January 31, 1983

TECHNICAL UPDATE

POLE POSITION™

"REWINDING THE PULLEY CABLE"

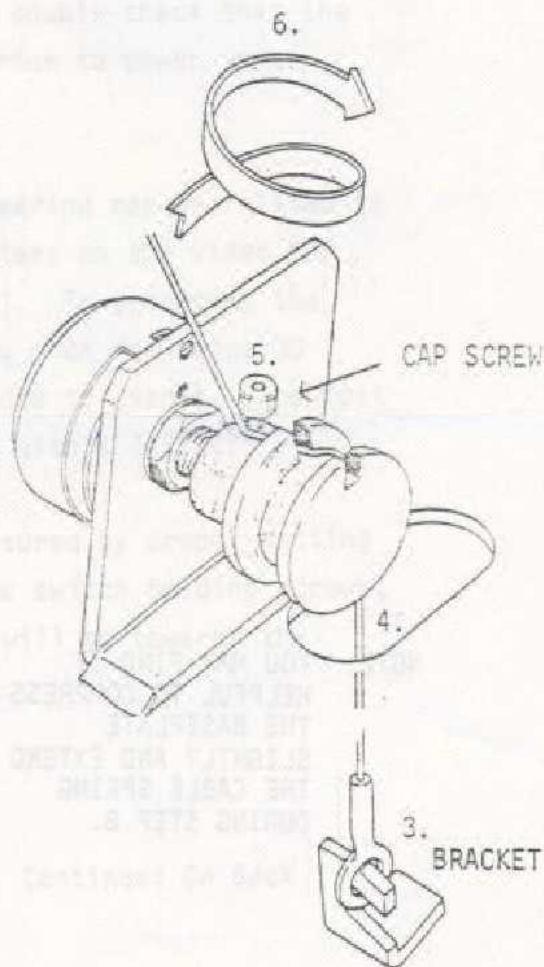
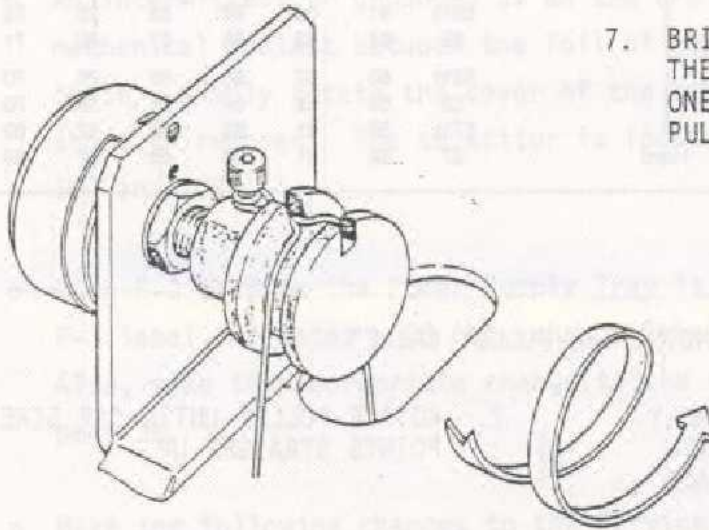
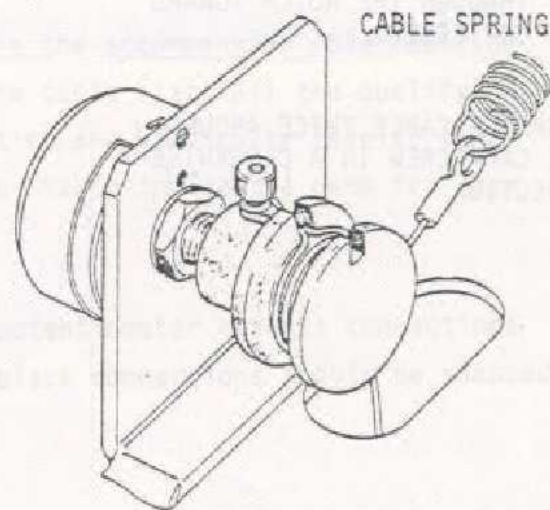
1. PLACE FOOT-PEDAL CONTROL ASSEMBLY UPSIDE DOWN ON WORK SURFACE WITH PEDAL IN FULLY-OPEN POSITION AND HINGED END AWAY FROM YOU.
2. ROTATE PULLEY UNTIL CAP SCREW POINTS STRAIGHT UP.
3. HOOK THE LARGER-DIAMETER EYELET OF THE CABLE TO THE FOOT-PEDAL BRACKET.
4. THREAD THE CABLE UP THROUGH THE BASE-PLATE OPENING.
5. WRAP THE CABLE 1/4 - TURN AROUND THE PULLEY AND BRING OUT THROUGH THE NOTCH TOWARD THE CAP SCREW.
6. WRAP THE CABLE TWICE AROUND THE CAP SCREW IN A CLOCKWISE DIRECTION.

7. BRING THE CABLE BACK THROUGH THE NOTCH AND WRAP ONE AND ONE-HALF TURNS AROUND THE PULLEY.

8. ATTACH THE SMALLER EYELET ON THE CABLE TO THE CABLE SPRING.

NOTE: YOU MAY FIND IT HELPFUL TO COMPRESS THE BASEPLATE SLIGHTLY AND EXTEND THE CABLE SPRING DURING STEP 8.
